From: BRYAN Martin (EXTERNAL AREVA) [Martin.Bryan.ext@areva.com]
Sent: Tuesday, October 19, 2010 8:03 AM
To: Tesfaye, Getachew
Cc: Hearn, Peter; KOWALSKI David (AREVA)
Subject: FW: DRAFT RESPONSES FOR FSAR Chapter 9 Weekly NRC Telecon
Attachments: Blank Bkgrd.gif; DRAFT RESPONSE RAI 351 Q.09.02.05-28.pdf; DRAFT FSAR Changes RAI 351 Q.09.02.05-23.pdf; DRAFT FSAR Changes RAI 351 Q.09.02.05-25 (Parts 1-3, 8).pdf; DRAFT FSAR Changes RAI 351 Q.09.02.05-28.pdf; DRAFT FSAR Insert RAI 351 Q.09.02.05-25 (Parts 1-3, 8).pdf; DRAFT RESPONSE + FSAR Changes RAI 351 Q.09.02.05-32 (Orig. 2c).pdf; DRAFT RESPONSE RAI 351 Q.09.02.05-23.pdf; DRAFT RESPONSE RAI 351 Q.09.02.05-25 (Parts 1-3, 8).pdf

Please transmit to Getachew Tesfaye the attached partial set of DRAFT responses to RAI 351 questions. These responses will be discussed at today's (10/19/10) FSAR Chapter 9 Weekly Telecon/GoToMeeting with the NRC.

Question 09.02.05-28:**Follow-up to RAI 175, Question 9.2.5-11:**

Question 09.02.05-23:**Follow-up to RAI 175, Question 9.2.5-05:**

Figure 9.2.5-1—Ultimate Heat Sink Piping and Instrumentation Diagram

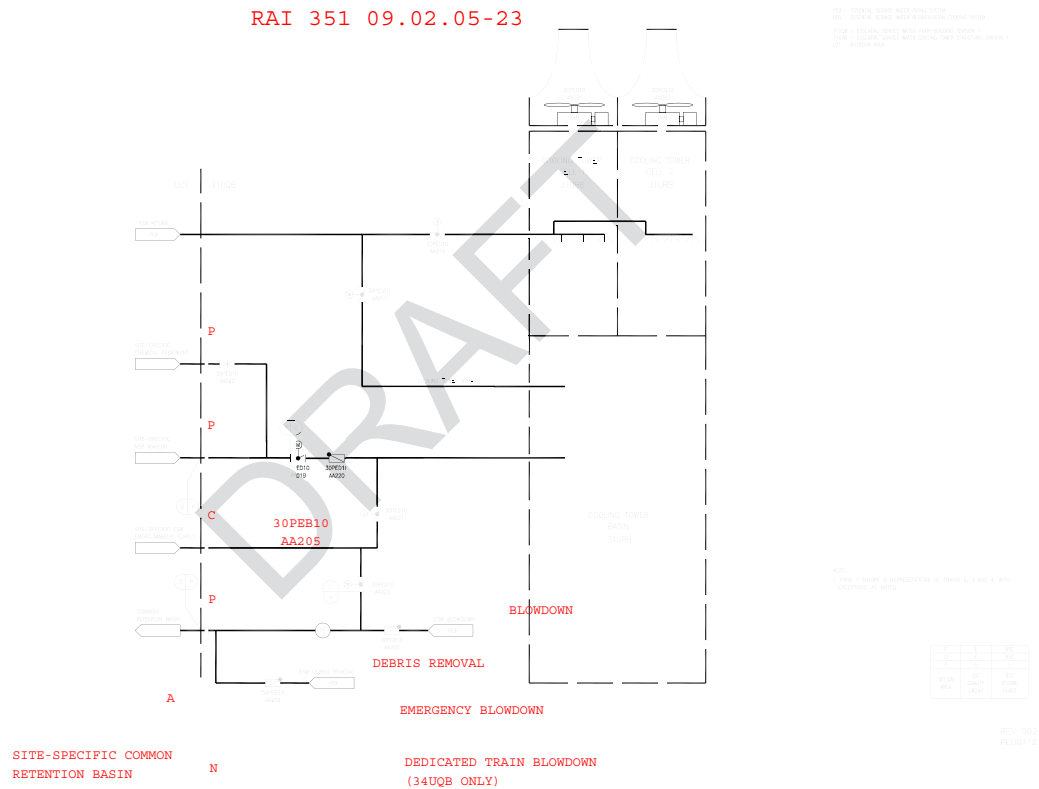
- a. Pipe sizes are not shown on the P&ID (Figure 9.2.5-1, "Ultimate Heat Sink Piping and Instrumentation Diagram"), and the system description in Section 9.2.5 does not explain the criteria that were used in establishing the appropriate pipe sizes (such as limiting flow velocities).

- c. Figure 9.2.5-1 does not show the location of indications (e.g., local, remote panel, control room), and identify the instruments that provide input to a process computer and/or have alarm and automatic actuation functions.

- d. Figure 9.2.5-1 does not show identify the normal valve positions are, identify the valves that are locked in position, and identify the valves with automatic functions; and these design features are not described in Section 9.2.5.

- e. Figure 9.2.5-1 shows the UHS bypass but flow rates are not provided for low load/low ambient temperature conditions to maintain essential service water (ESW) cold water temperature within established limits.

- f. The UHS fan alarms are not discussed in the FSAR.
- g. Figure 9.2.5-1 does not show the cooling tower basin instruments (level and temperature).

- a. Dedicated and emergency ESWS blowdown are not shown on FSAR Tier 2 Figure 9.2.5-1 as UHS support systems
- b. Interface flange connections are not shown on FSAR Tier 2 Figure 9.2.5-1 for the dedicated and emergency ESWS blowdown support system.

- c. FSAR Tier 2 Figure 9.2.1-1, Sheet 3, and Figure 9.2.5-1 both show that the chemical treatment system is only connected to the normal makeup system and not to the safety-related emergency makeup system. This appears to be in error and the applicant should correct or explain.

UHS Makeup Water Test Isolation Valves 30PED10/20/30/40AA023 and the associated cross-connect line are removed from U.S. EPR FSAR Tier 1, Figure 2.7.11-1 Sheets 1-4 and Sheets 6-9 and U.S. EPR FSAR Tier 2, Figure 9.2.5-1. Valves 30PED10/20/30/40AA023 are removed from U.S. EPR FSAR Tier 2, Table 3.9-6-2. They are part of the conceptual site-specific UHS support systems as indicated in the attached markup of U.S. EPR FSAR Tier 2, Figure 9.2.5-2. The conceptual function for the valve is each valve is manually opened during surveillance testing of its UHS division.

- a. See information above concerning the locations in the FSAR for UHS **valves and instrumentation information and clarification of FSAR figures**. The emergency ESWS blowdown system is shown on U.S. EPR FSAR Tier 2, Figure 9.2.1-1, Sheet 1, Essential Service Water System Piping & Instrumentation Diagram. The dedicated ESWS blowdown system is shown on U.S. EPR FSAR Tier 2, Figure 9.2.1-1, Sheet 4. A conceptual design for the emergency ESWS blowdown system is indicated in the response to RAI 175 Supplement 2, Question 09.02.05-20, Figure 9.2.5-2 [[Conceptual Site-Specific UHS Systems]]. Figure 9.2.5-2 will be revised to show the dedicated blowdown system and the change in classification of emergency ESWS blowdown piping indicated in the response to RAI 351 Question 09.02.05-22.

- b. Refer to response to RAI 351, Question 09.02.05-22, markup of U.S. EPR FSAR, Figure 9.2.1-1, Sheet 1 for additional information concerning the emergency ESWS blowdown system. U.S. EPR FSAR Tier 2, Figure 9.2.1-1 Sheet 4 will be revised to show the off-

page connection for the ESWS dedicated blowdown system to Tier 2 Figure 9.2.5-1 and the site-specific interface.

- c. This is not in error. The chemical treatment system is non-safety site specific system that provides water treatment chemicals to the normal make up water system. The chemical treatment system is not needed during emergency operation. Details related to chemical treatment for the safety-related emergency makeup system are the responsibility of the COL applicant as indicated in Tier 2 Figure 9.2.5-2.
